Fishermans Bend Standing Advisory Committee – Tranche 1C Report

**Port Phillip Planning Scheme draft Amendment
C166port
256-262 Normanby Road, South Melbourne (Site 2)**

6 August 2020

Figure 5 Comparison of Proponent and Council’s preferred indicative tower floorplates

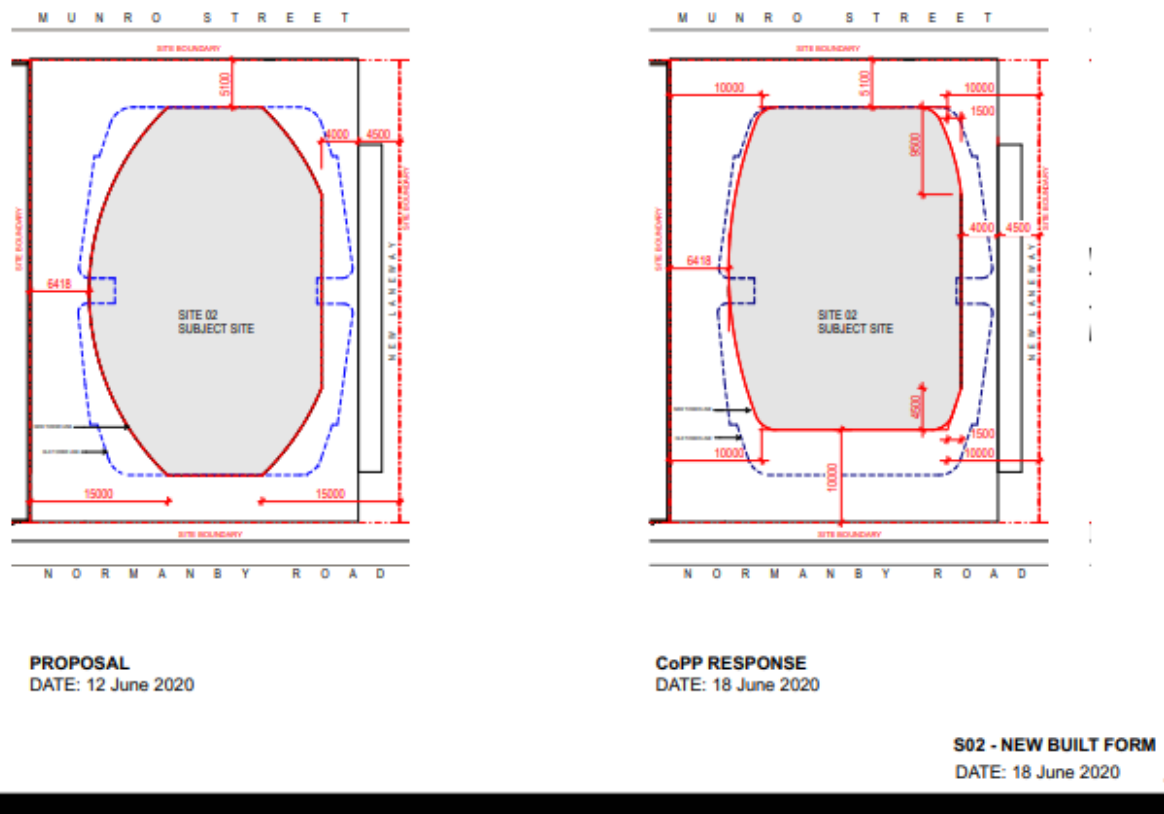
- the podium setback to the laneway should be retained at 4.5 metres and not be reduced to 4.45 metres (to overcome potential complications with applying Clause 2.8 of DDO30, referring to streets less than 9 metres wide)
- the front tower setback to Normanby Road should be increased to 10 metres, consistent with approved setbacks on the opposite side of Normanby Road
- the rear tower setback to Munro Street should be increased to 10 metres, although it would support a 5 metre setback if the 10 metre setback to Normanby Road was provided
- while the tower side setbacks *“are a significant improvement on the built form”*, the proposed maximum 15 metre side setback at the front and rear (largely a product of the elliptical building shape proposed) are *“excessive”* and should be reduced to a maximum of 10 metres.

The indicative setbacks of the ‘new built form’ are depicted on the left of Figure 5 overlaid on the amended plans indicative tower footprint. The same exercise is undertaken on the right of the figure for Council’s preferred indicative tower setbacks.

The Committee does not consider that Council's proposed floorplate is a suitable design response for this site as it would result in wider, bulky frontages. Further, while it would somewhat decrease overshadowing to Normanby Road due to the 'cut-off' southern end and a resulting shorter shadow, it would increase overshadowing to the laneway due to the wider Munro Street frontage and would narrow diagonal view lines between the buildings. The Proponent provided an indicative tower floorplate layout (Document 111) in support of its proposal shown in Figure 7.

In summary, the disadvantage of the longer shape (towards the south) is offset by the benefits of the narrower frontage (particularly to the north) in an overall clearer and more convincing design approach. This is also more consistent with the high quality design sought for the Precinct. The Committee therefore considers that the proposed setbacks are a suitable design response to DDO30 and preferred character.

Figure 8 Council's indicative changes to entry arrangements at Montague Street

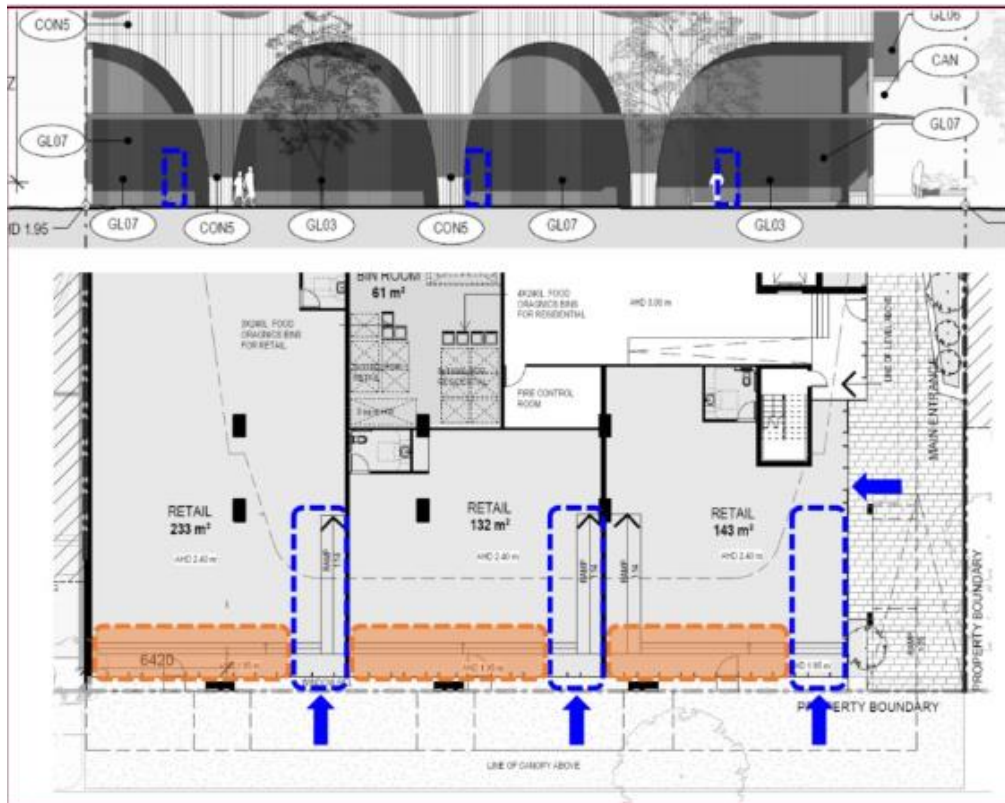
Council suggested this issue could be addressed as part of the re-working of the facade to achieve more intuitive locations for entrances, with consolidated steps and ramps or lift for the front tenancies and extending retail floorspace to the facade as indicated in Figure 7.
